Job: Old Beza Hospital  
5th Beza

Job No: AJ 3585

Date: 26.2.06.

**SITE INSPECTION REPORT/INSTRUCTION.**

Chimney Support (at roof/ceiling) instruction.

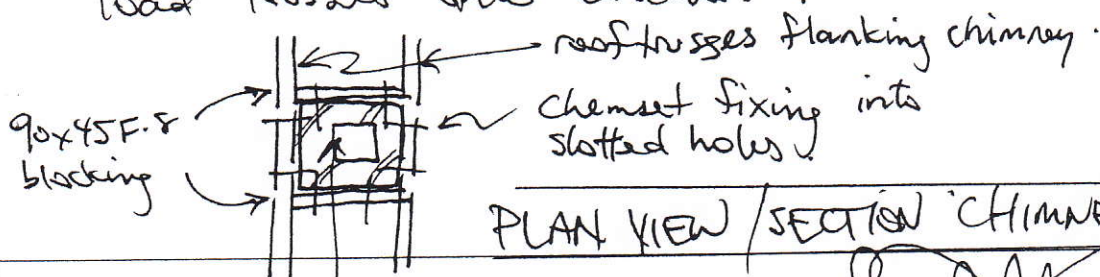
All chimneys are to be flanked (i.e. fixed to) by 2 roof/ceiling trusses on parallel faces of chimney.

Perpendicular chimney faces are to be timber blocked with 90 x 45 F.F kd pine members to reach ceiling and roof chord of truss. i.e. fixed to AS1684 i.e. AS1720 requirements i.e. BCA. Roof i.e. ceiling battens locate here also.

Chimneys are to be fixed to truss top i.e. bottom chords and perpendicular blocking members with 2 equally spaced M10 chemset or epoxy set (to brickwork) anchors bolt fixed with nut i.e. washer through appropriate vertically slotted holes in truss chords to allow for truss vertical deflection up i.e. down so as not to load trusses onto anchors.

TYPICAL TOP  $\#$  TIE DOWN SECTIONS.

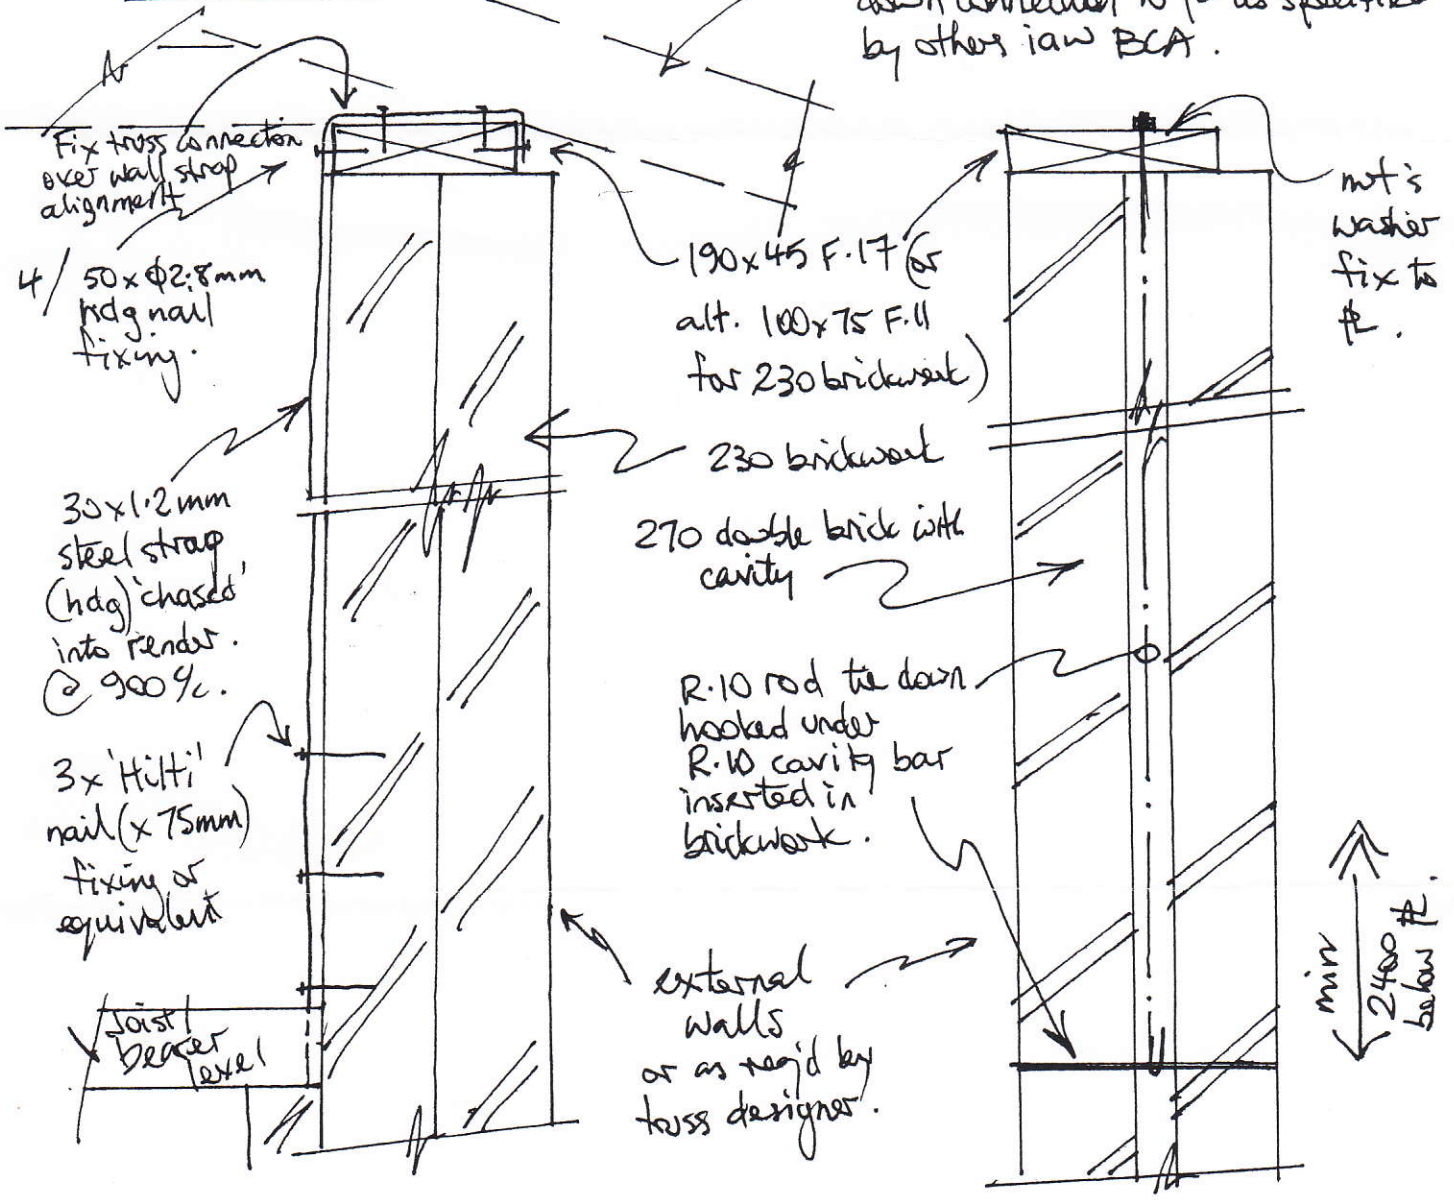
Roof tie down detail.

Pre fabricated timber roof truss tie down connection to  $\#$  as specified by other iaw BCA.
